CHILDREN'S HOSPITAL
OF ORANGE COUNTY
455 S. Main St.
Orange, CA 92668-3874

TOWER II

MECHANICAL DETAILS -
PIPE SUPPORT DETAILS

M10.06

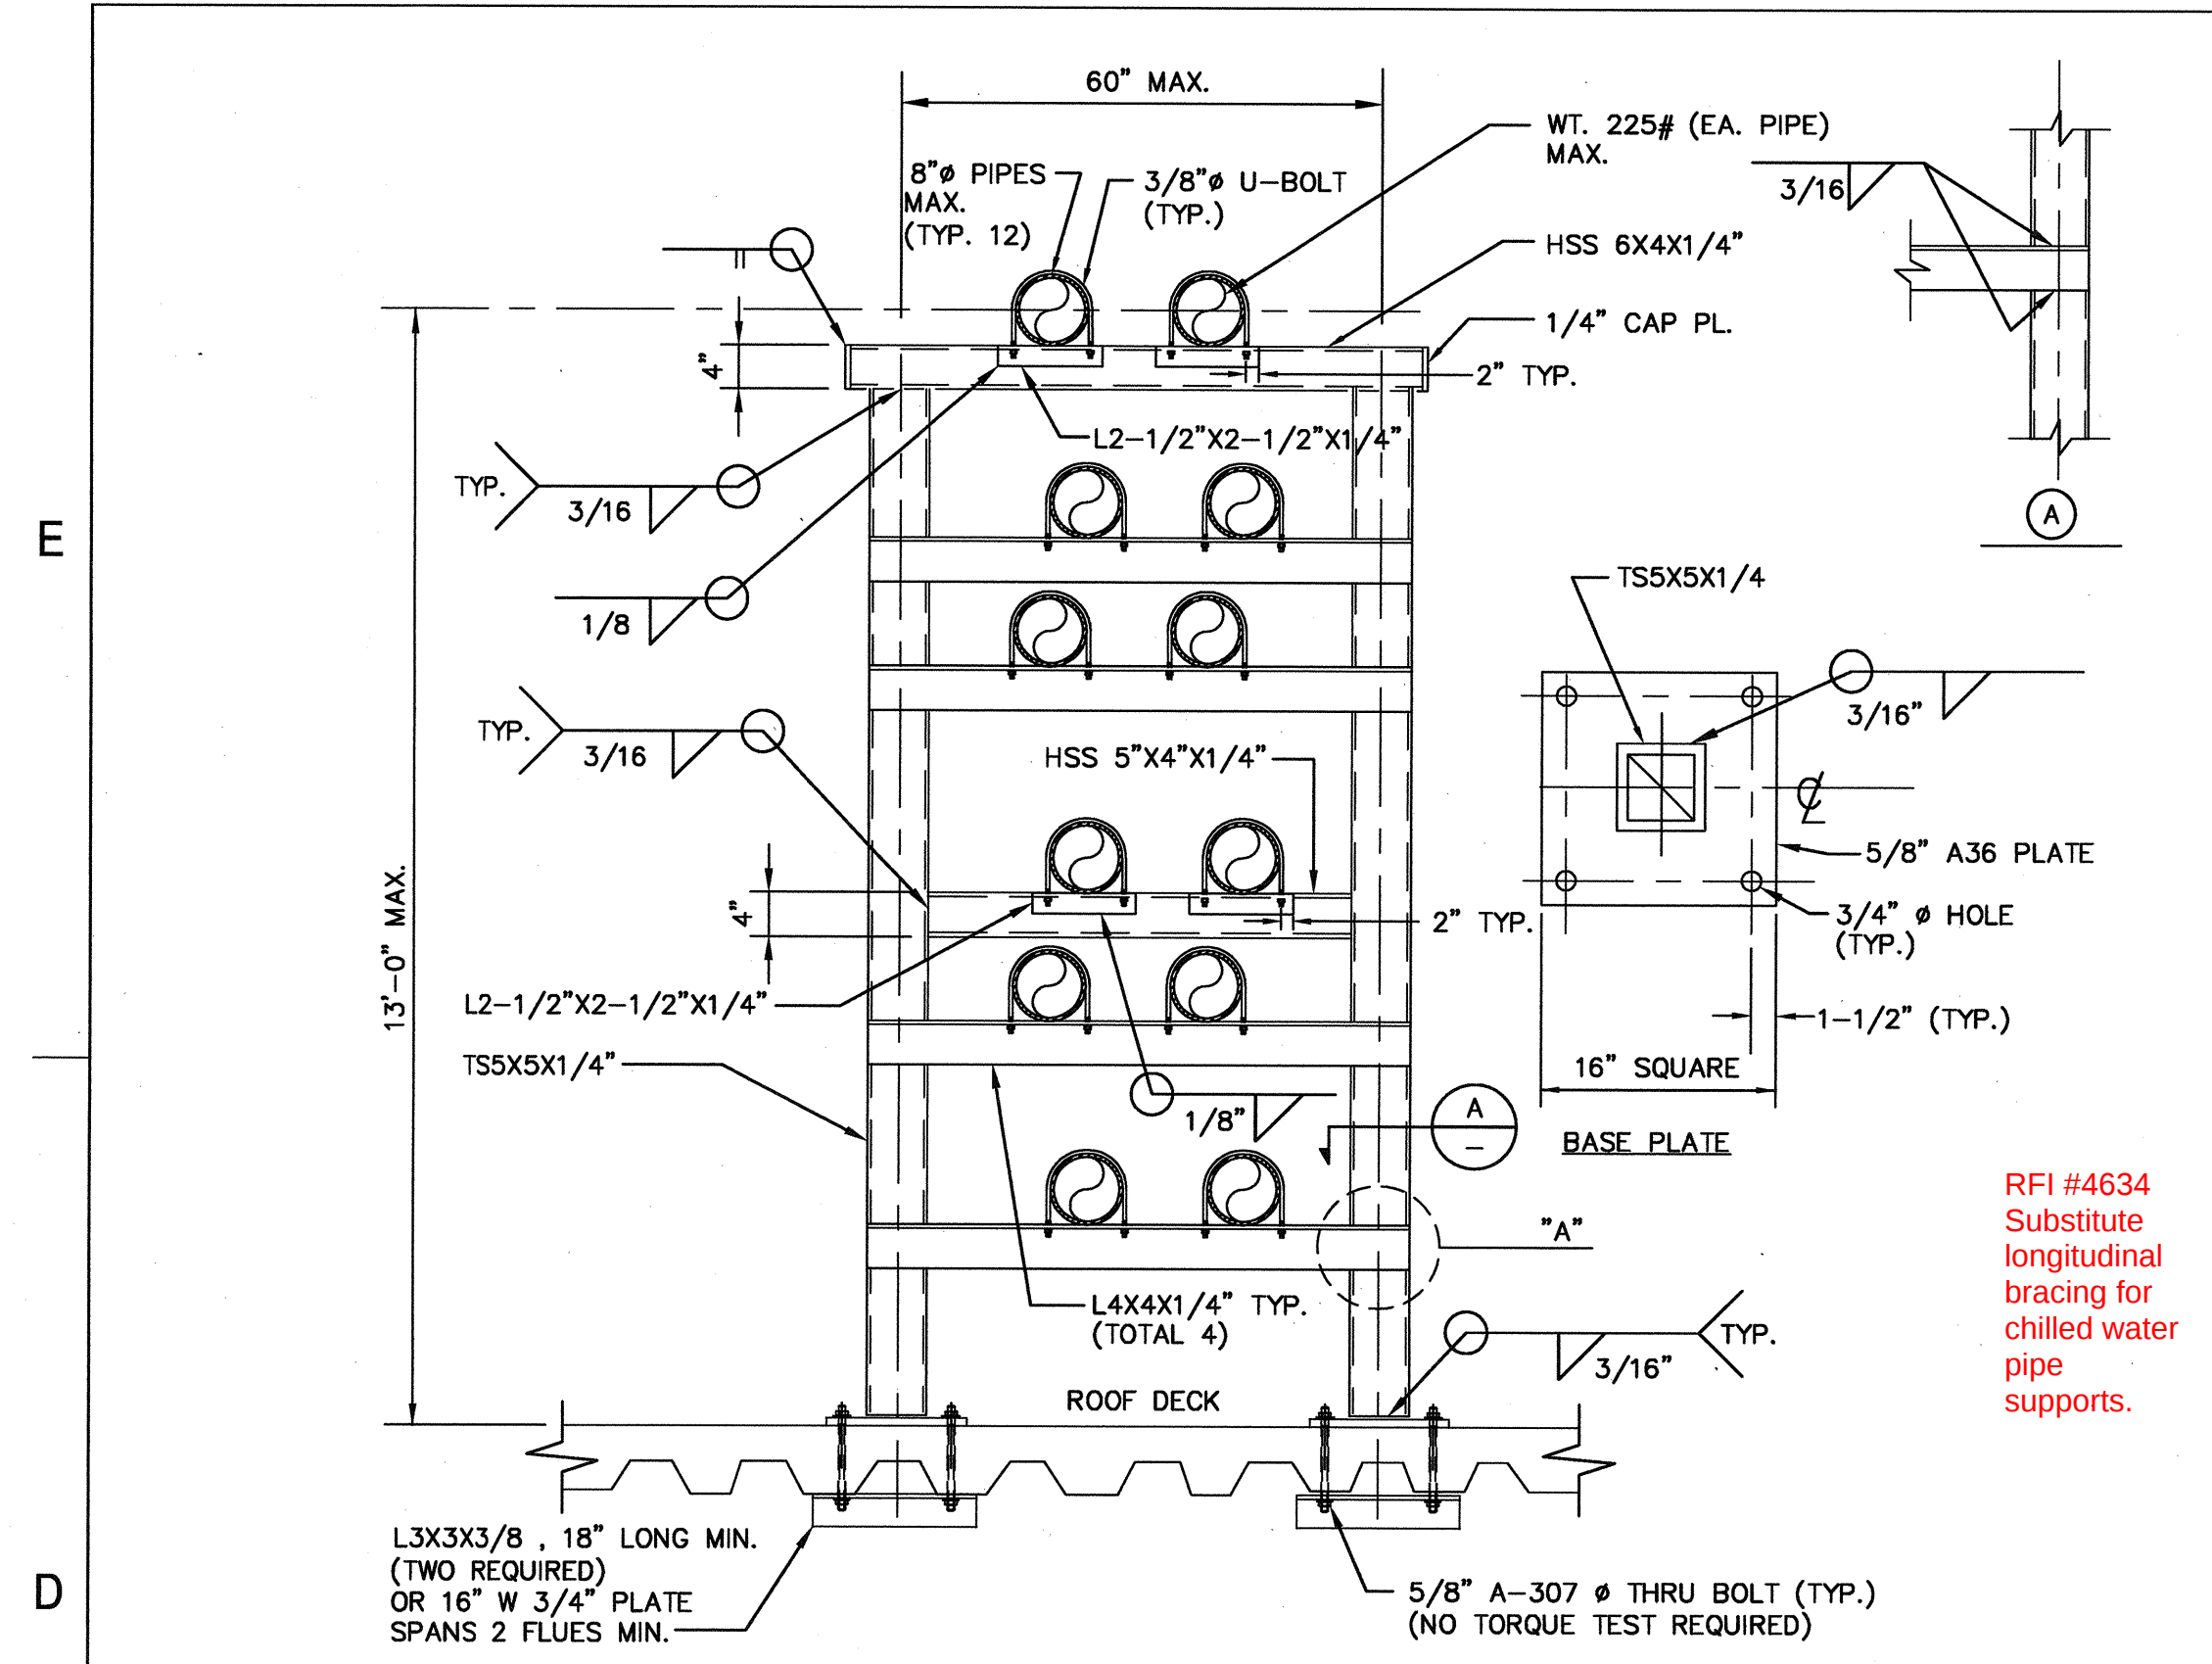
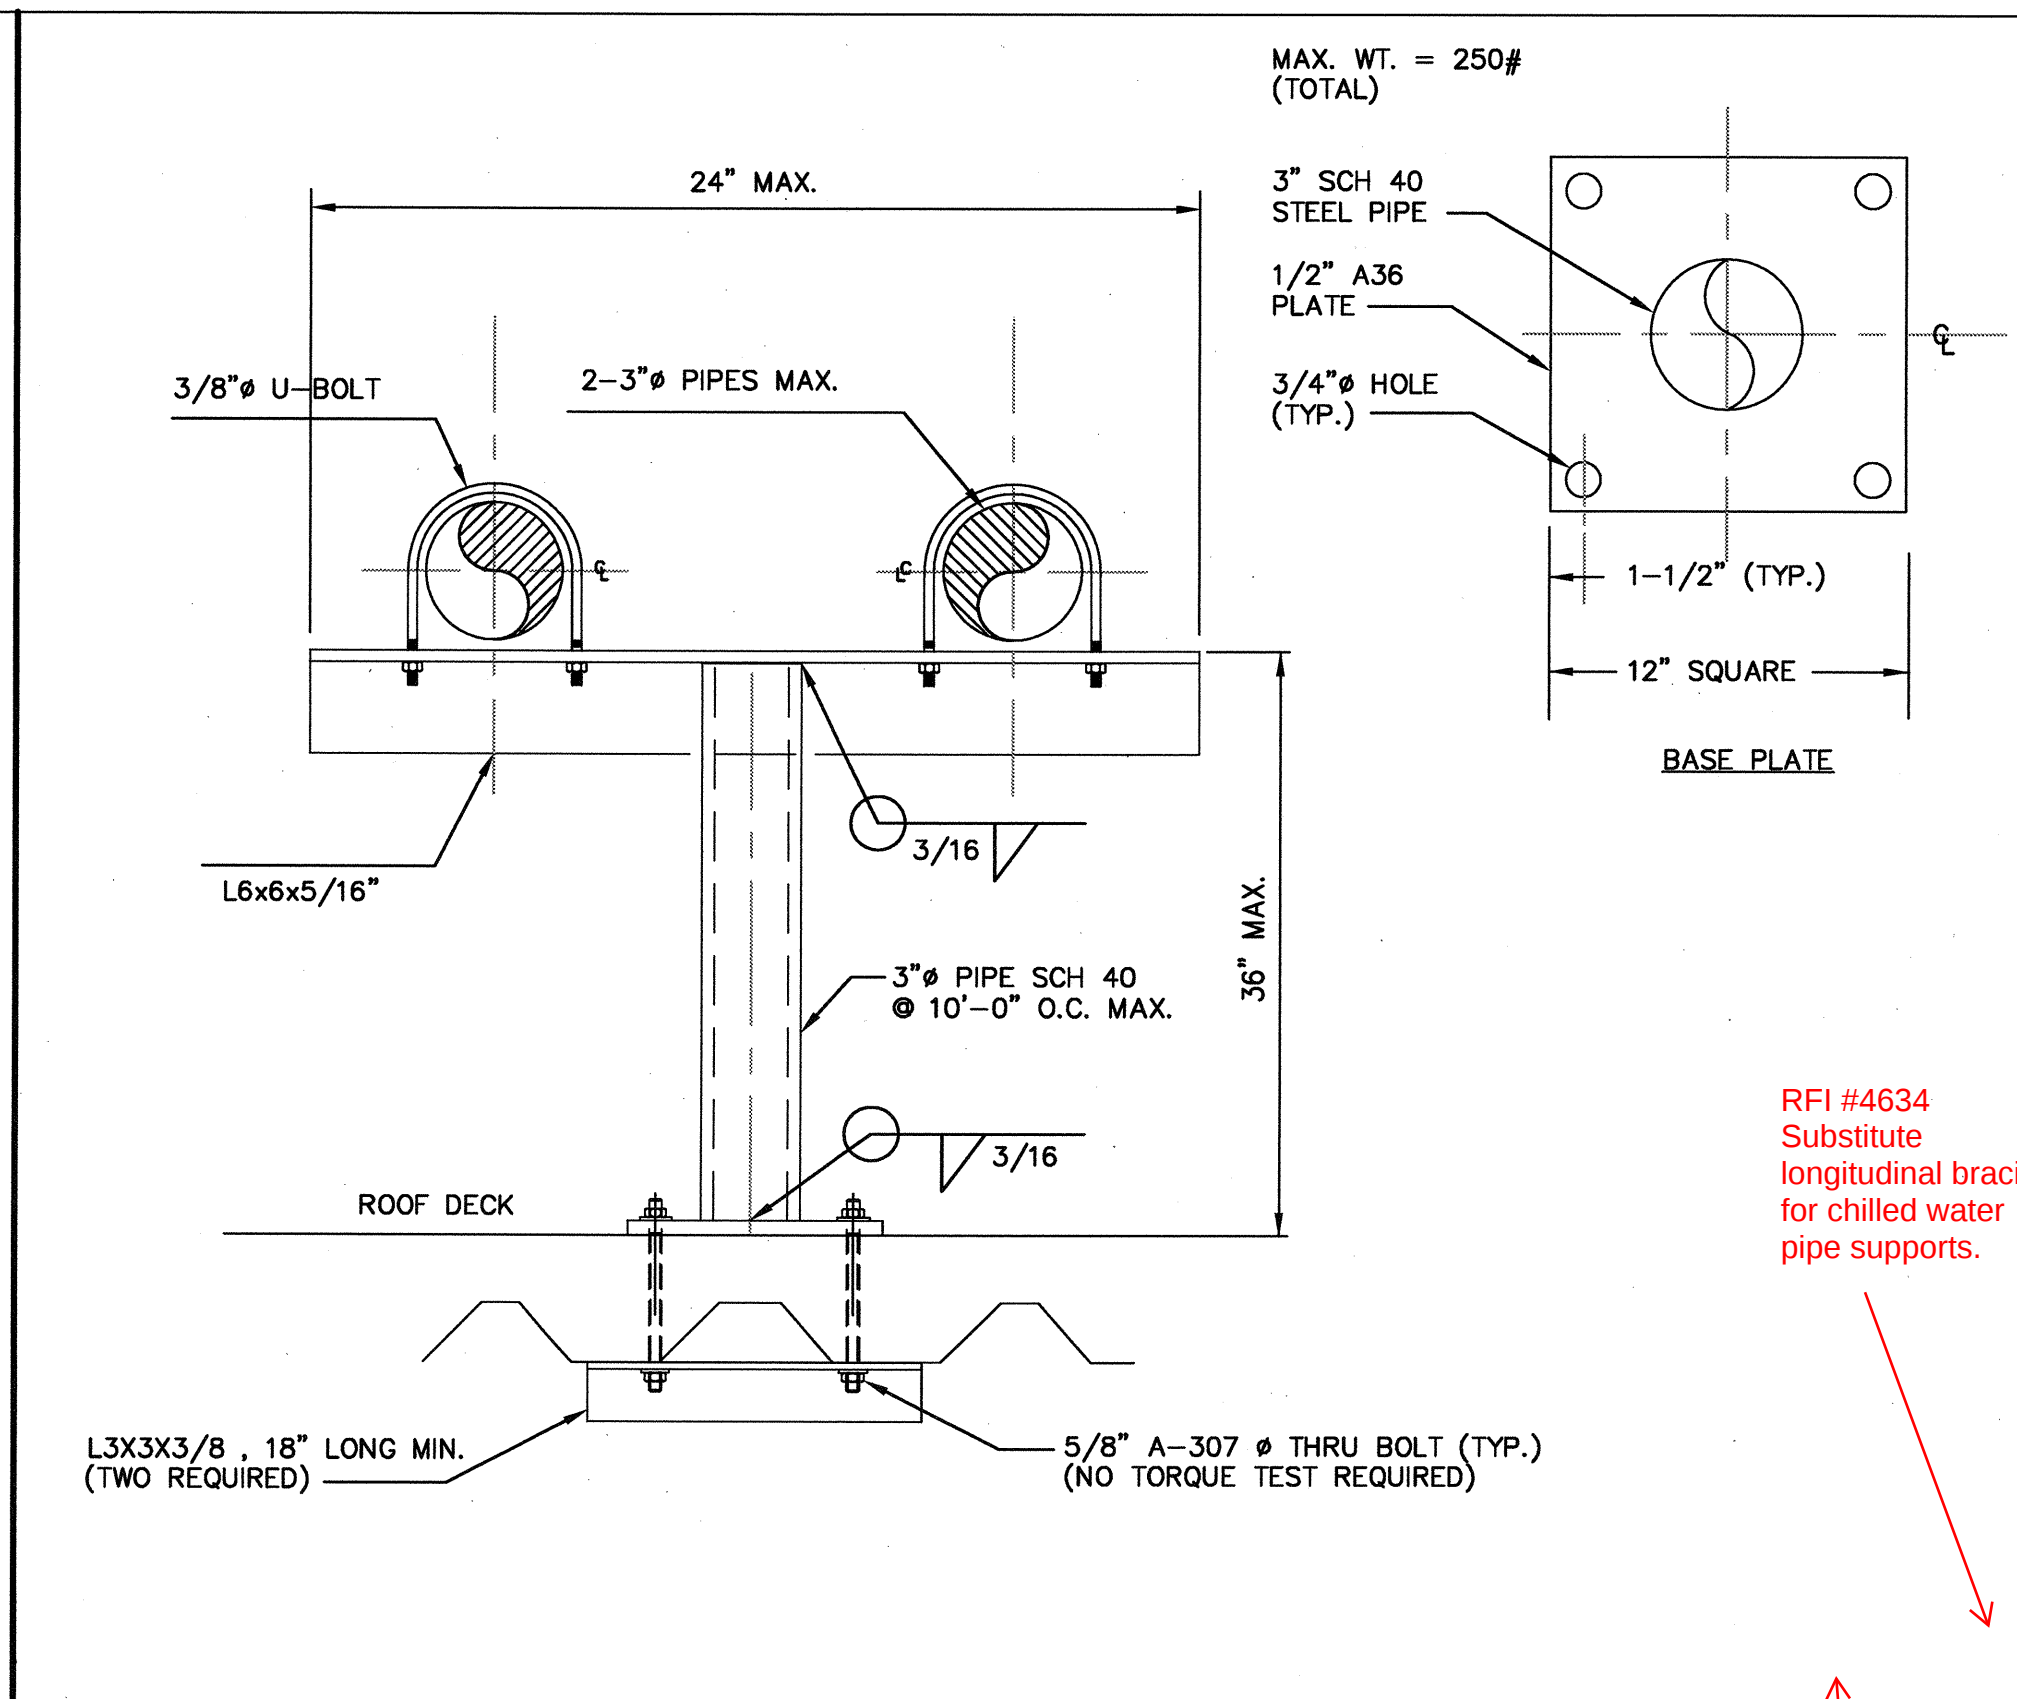
RFI #3944

Temperature controls conduit
acceptable to attach to pipe and duct
supports on roof.
